State of California
The Resources Agency
DEPARTMENT OF WATER RESOURCES
DIVISION OF SAFETY OF DAMS

INSPECTION OF DAM AND RESERVOIR IN CERTIFIED STATUS

Name of dam Oroville Dam Dam No. 1-48 County Butte
 Type of dam Earthfill Type of Spillway Gated Concrete Weir and Chute
 Water is 114.32 feet below spillway crest and 222.52 feet below dam crest.
W.S. 898.96 feet
 Weather Conditions Sunny, and hot
 Contacts made Alex Samaan, OFD; David Panec O&M.
 Reason for inspection Periodic Evaluation (2nd inspection)

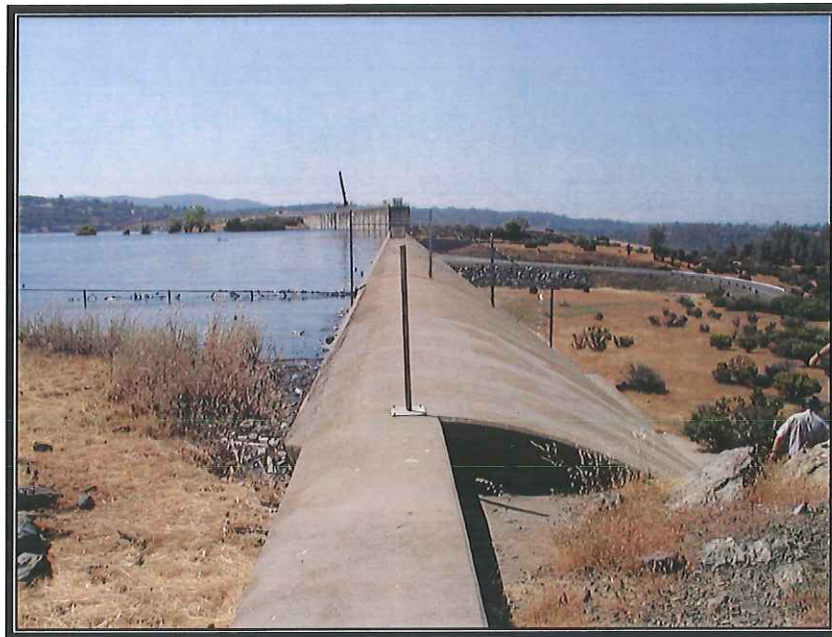
3. Seal leakage at gate 3 is shown. During the inspection, the stoplogs were installed in preparation for an evaluation of the sealing problem.
